Economic Commission for Europe**Inland Transport Committee****Working Party on the Transport of Dangerous Goods****116th session**

**Proposals for amendments to annexes A and B of ADR:
construction and approval of vehicles****Section 9.7.6 – Rear protection of vehicles****Transmitted by the Government of the United Kingdom of Great
Britain and Northern Ireland****Summary*

Executive summary:	Proposals to clarify the requirements of ADR 9.7.6 in respect to the rear protection of vehicles and the minimum distance required between the rear of a tank and the rear of the bumper to ensure a uniform interpretation.
Action to be taken:	Amend ADR 9.7.6.
Related documents:	ECE/TRANS/WP.15/2020/5 and informal document INF.16 (108th session); ECE/TRANS/WP.15/2021/7 and informal document INF.5 (109th session); ECE-TRANS/WP.15/253 paragraphs 19-22; ECE/TRANS/WP.15/AC.1/158/Add.1 (item 9); ECE/TRANS/WP.15/2023/1 and informal document INF.9 (113th session); ECE/TRANS/WP.15/262; ECE/TRANS/WP.15/2023/13 and informal document INF.22 (114th session); ECE/TRANS/WP.15/2024/6; ECE/TRANS/WP.15/267.

Figure 9.7.6.1.1

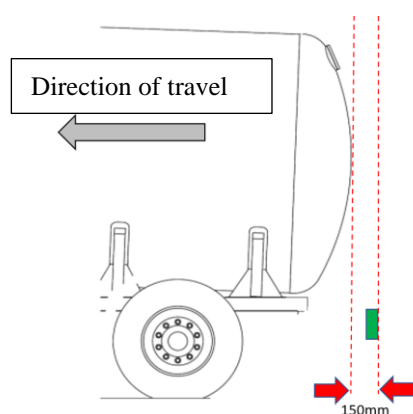
5. Based on feedback from delegations during 115th session strong support exists for all tanks, irrespective of their construction, to have a bumper positioned at least 150 mm from the rearmost face of the bumper to the rearmost point of the tank (see figures 9.7.6.1.1 and 9.7.6.1.2 below). This proposal would offer a consistent measurement across all types of tanks and give a clear interpretation regarding standards and approvals.

The rearmost face of the bumper shall be positioned at least 150 mm from the rearmost part of the tank (or of its projecting fittings in contact with the substance being carried). This shall be measured as specified in figure 9.7.6.1.1, figure 9.7.6.1.2 and 9.7.6.3.
